FILE P. I. No. 0008367, Fulton County **OFFICE** Preconstruction
CSMSL-0008-00(367)
Midtown LED Traffic Signal Head Upgrades **DATE** April 5, 2007
FROM *Cyahn Kunkle* Genetha Rice-Singleton, Assistant Director of Preconstruction
TO *ra-* David E. Studstill, Jr., P.E. Chief Engineer

SUBJECT: PROJECT CONCEPT REPORT

FILE: CSMSL-0008-00(367) Fulton
P.I. No. 0008367
LED Signal Heads

Midtown LED Traffic Signal Head Upgrades

PROJECT LOCATION MAP

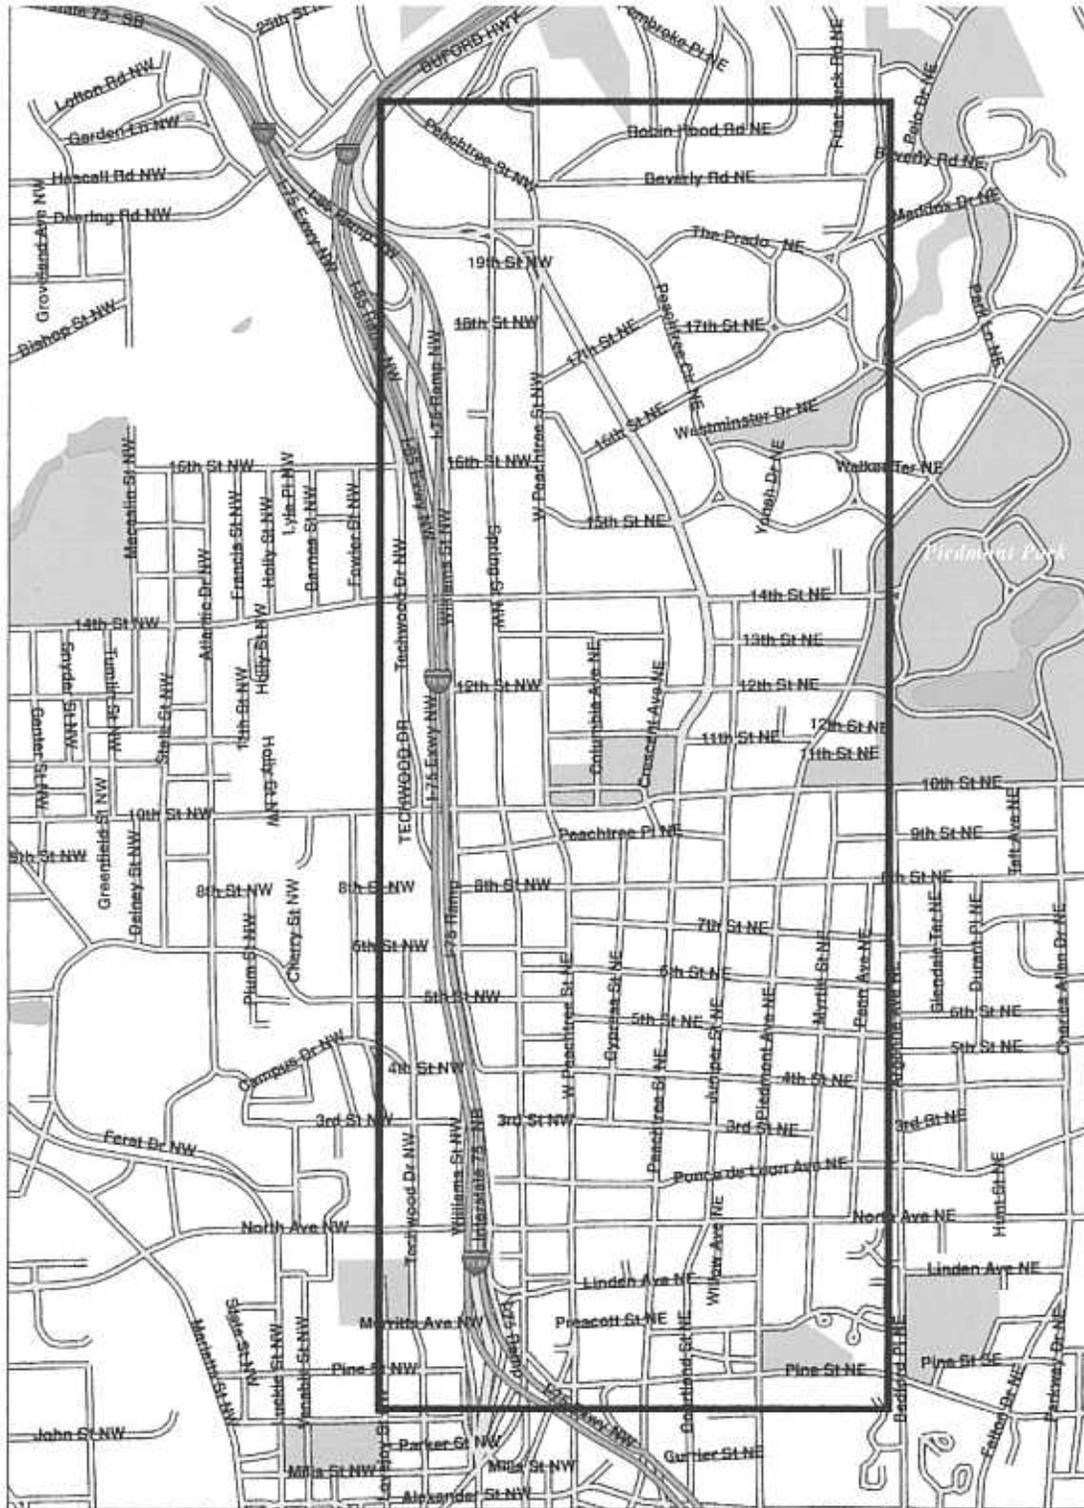
B. Page One: Project Location Map

- a. Delete, small Project Location Map and replace with the enlarge Project Location Map.

The items under sections A, B & C will be incorporated into the concept report. In response to Section D, a spreadsheet format was utilized because this is a one-for-one swap for signal heads and pedestrian heads and accurate signal designs are not available for all existing signals. A team of one signal technician and one engineer visited each intersection and determined the exact number, configuration, approach and mounting of signal heads and pedestrian heads for every intersection, including the mounting height. There will be no activities or signal upgrades that would trigger a signal permit revision.
